FIG. 2A

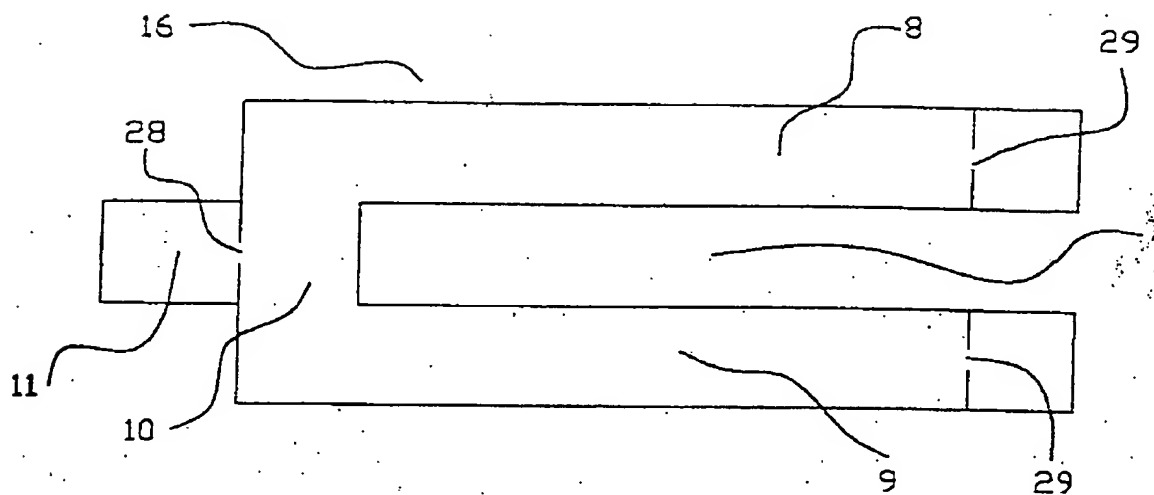
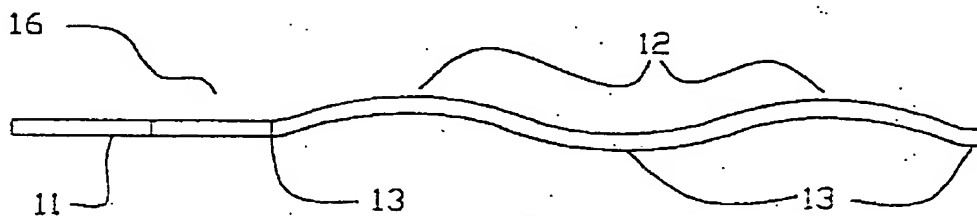
As can be seen in FIGs. 2A and 2B of the instant application, the peaks and troughs travel across both arms and are in a direction that is parallel to a junction that separates the arm portion from the other portion of the body.

A side view of the shim 16, as shown in FIG. 2B, shows the wave shape, which has well defined peaks 12 and troughs 13 in the arms. See also, instant specification, para. 0048. Therefore, the wave travels along the length of the arms. Because of this wave orientation, the arms 8 and 9 of the shim, when compressed, are able to naturally "extend" in a direction away from the main body section 10 to which the legs are attached.

FIG. 6

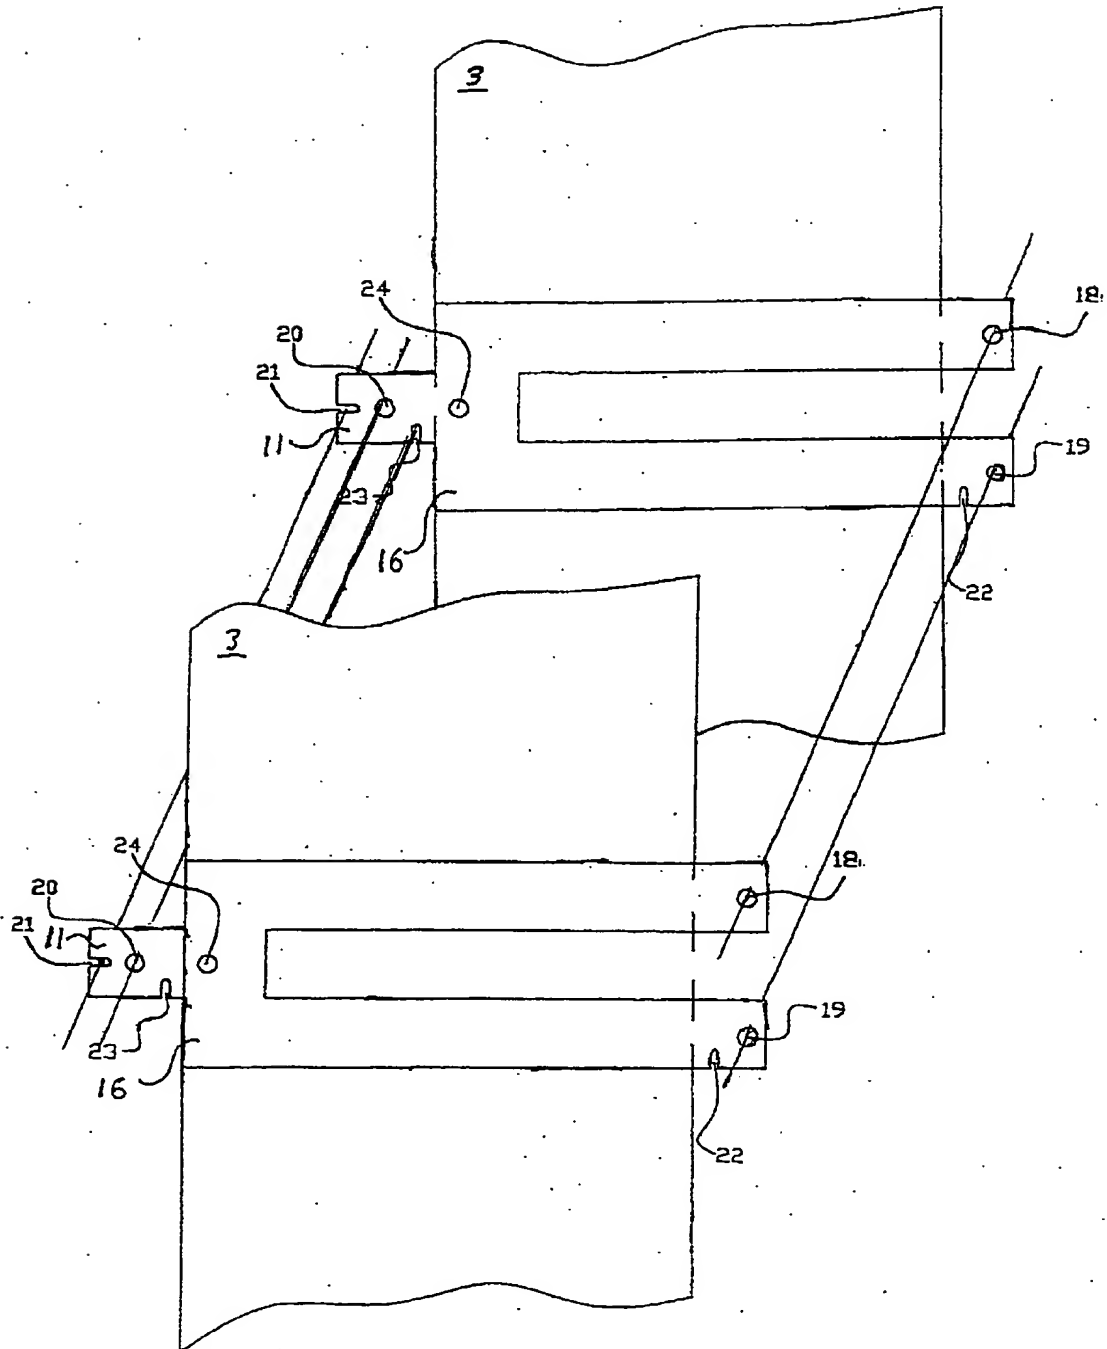
As noted above, the Examiner objected to the drawings under 37 CFR 1.83(a) for features claimed but not shown in the drawings. Specifically, the Examiner stated that "the method for aligning at least two elements by connecting a guide-line between corresponding grooves or holes in the [] must be shown or feature(s) cancelled from the claim(s)."

FIG. 6 has been added to the instant application. FIG. 6 shows that described in paragraph 0054 and claims 21-24 of the application as originally filed. Specifically, FIG. 6 shows two shims 16 utilized to align several frames 3 along a single plane by connecting a guide-line, such as a string, through grooves 21 and/or 23 of the tabs 11 of the shims 16 located between the frames 3. New FIG. 6 also shows thru-holes 20, 24, 18, and 19, and slot 22 being used for alignment of the frames 3. No new matter was added by the addition of FIG. 6.
